IEEE802.3 4P Task Force
Channel Pair To Pair Resistance Imbalance
(End to End System Imbalance)
Ad Hoc

Meeting #3: Rev 004, Thursday April 24, 2014

Meeting #4: Rev 005, Thursday May 1, 2014

Meeting #4: Rev 006, Thursday May 8, 2014

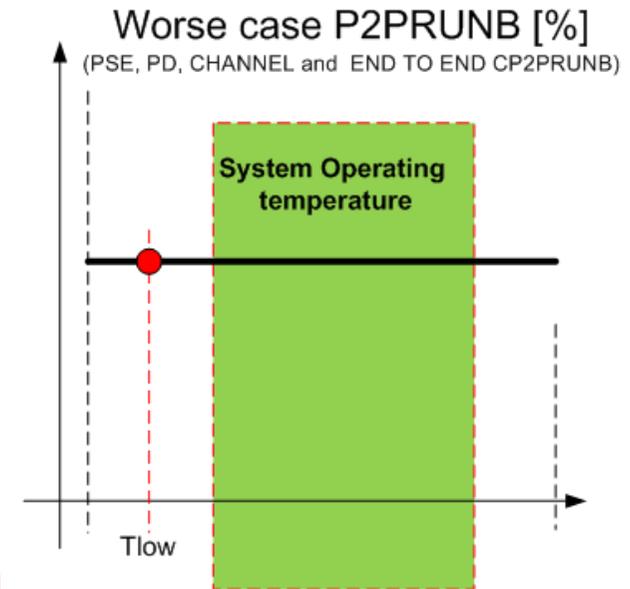
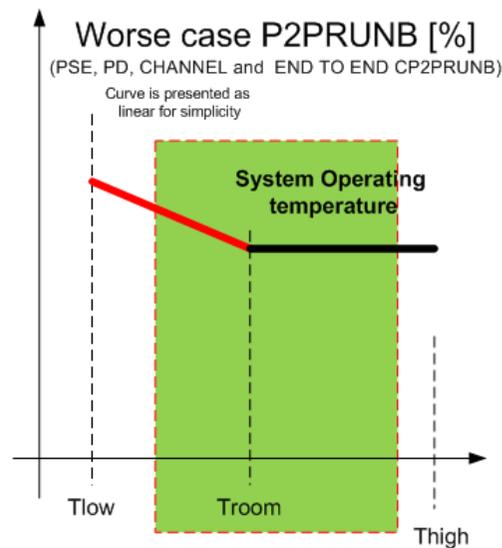
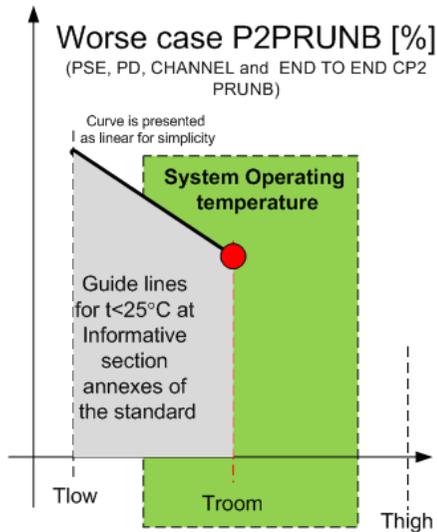
(2) Jeff/Wayne: Mandatory section we need to define at 25degC and (-TBD)

(3) Jeff: To define one number which is the worst case and will include low temperature (similar to a worst case of insertion loss at high temp.)

Yair: (May 1, 2014) During reflector discussion we saw that insertion loss is define at 20degC and at higher temperature derating is allowed by using shorter cable which means that it insertion loss is not specified for worst case operating temperature (ANSI/TIA 568-C.2 Annex G Clause 6.4.7.

Straw Poll Results

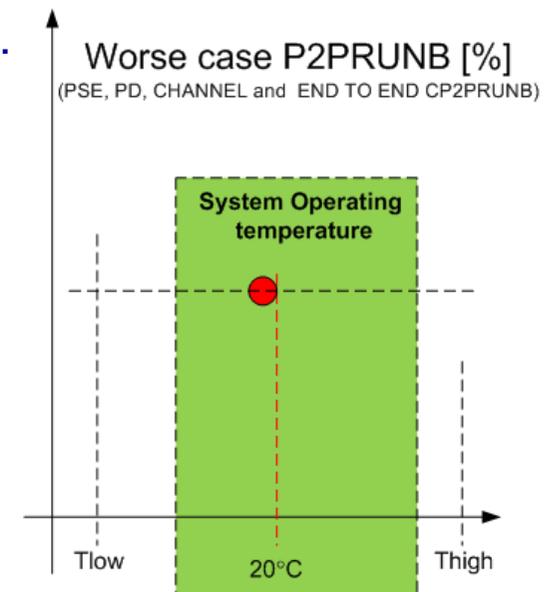
Name	Options			Notes
	1	2	3	
Yair Darshan / Microsemi	x			Without having the informative part and using clause 33.7.7 instead (Option 1b or name it option 4)
Fred Schindler / Seen Simply			x	
Ken Bennett / Sifos	x			
Yseboodt, Lennart / Philips	x			
Jeff Heat / LT				Accept suggested proposal for option 4 (see mail) which is option 1b (to ask for email confirmation).
Wendt, Matthias / Philips	x			
Dave Dwelley / LT	x			
Rimboim Pavlik / MSCC	x			
Christian Beia / ST			x	
Belopolsky Yakov / BEL	x			
??

- Results of the straw poll
- 7 for option 1 (5 for 1a or 1b, 1 for 1b)
- 2 for option 3
- 1 for 1b ?? (waiting for confirmation)

General Channel Model and its components that we have used.

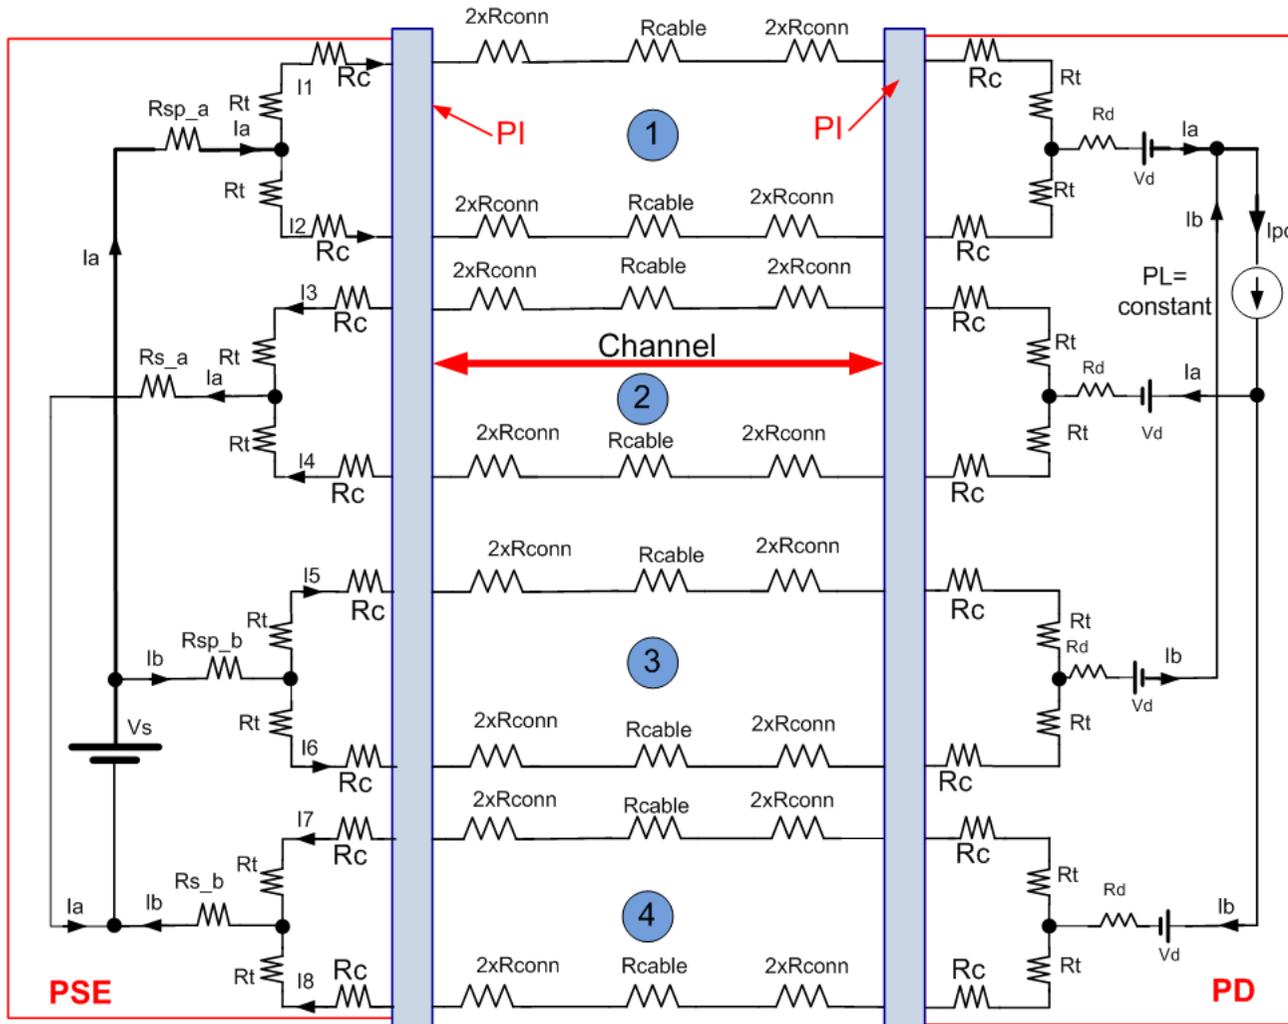
1. Adding resistors on positive path for general model (R_{sp_a} and R_{sp_b}). It can be set to zero or $>zero$ pending the case being investigated.
2. Adding equipment connectors per Wayne's comment. So total end to end channel connectors is 6 max.
3. The formal channel definition is marked in red arrow.
4. Our work addresses also the internal application resistance of known components that are used

PSE_PI Pair to Pair Resistance Unbalance

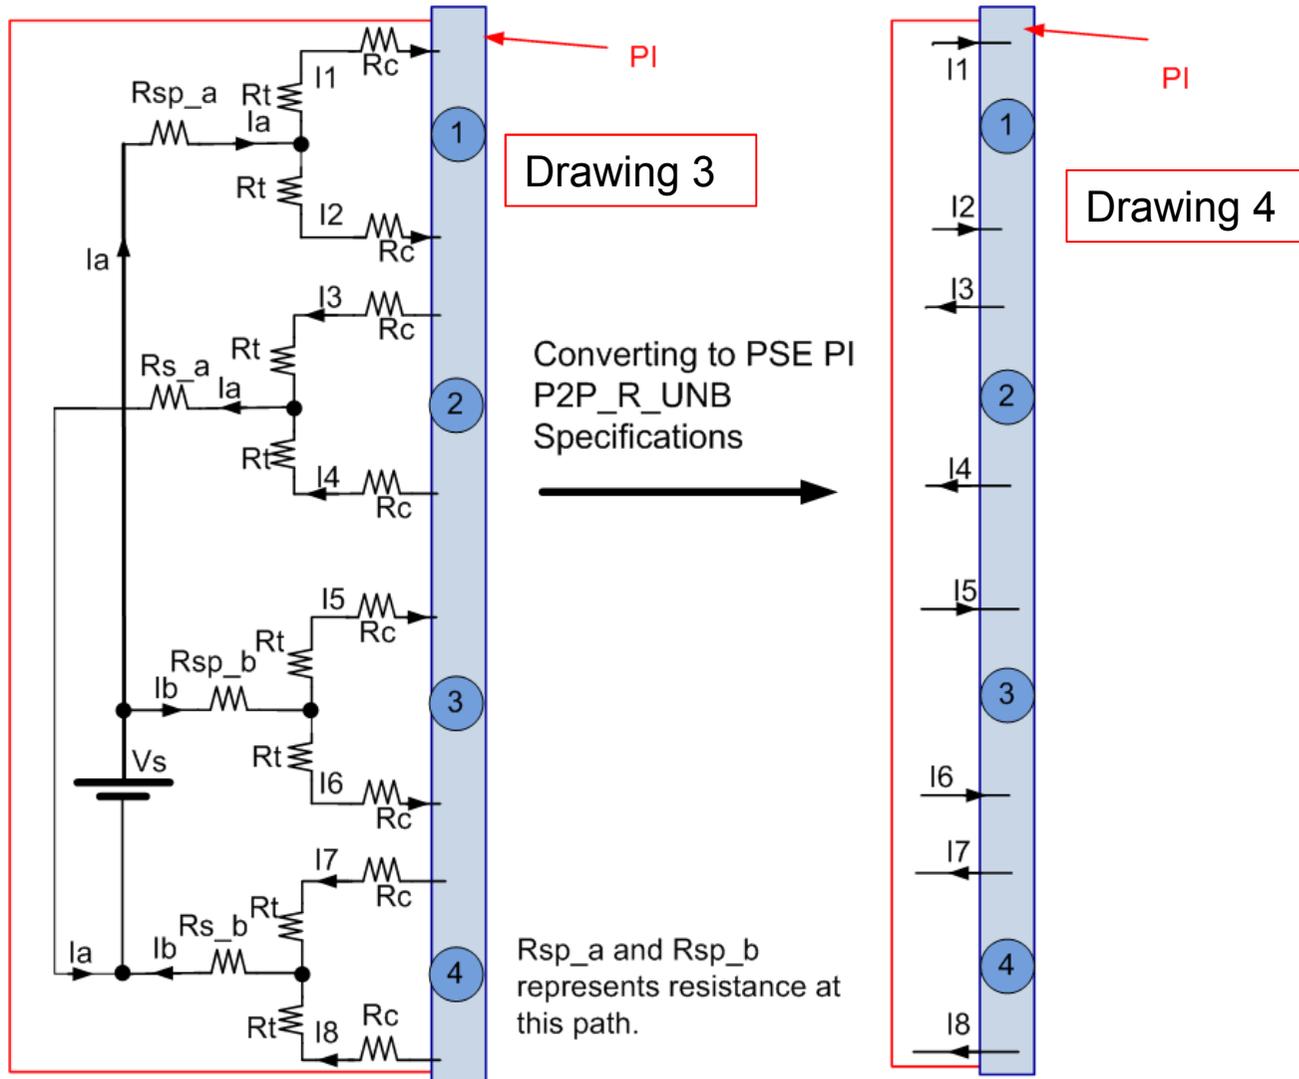
- To specify test setup as well

PD_P1 Pair to Pair Resistance Unbalance

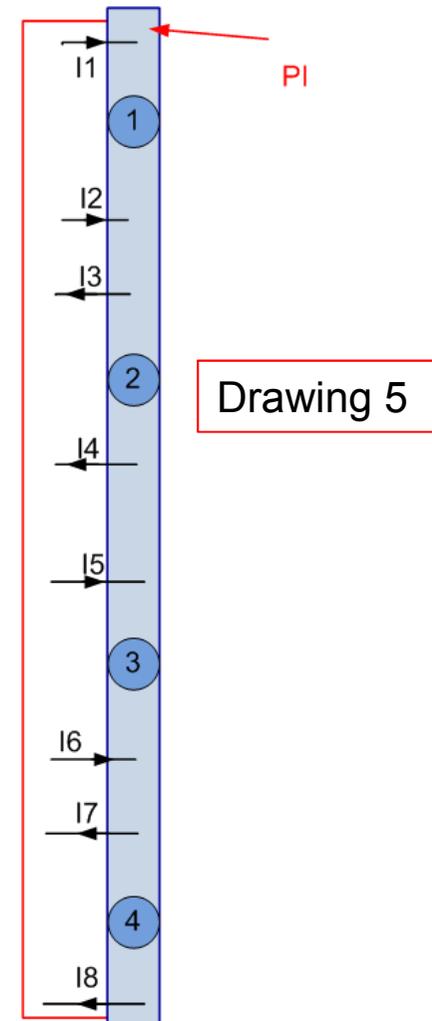
- Same concept for PD PI P2P_R_UNB definitions
- To specify test setup
- We may need to define P2P voltage offset difference in addition to P2P resistance unbalance
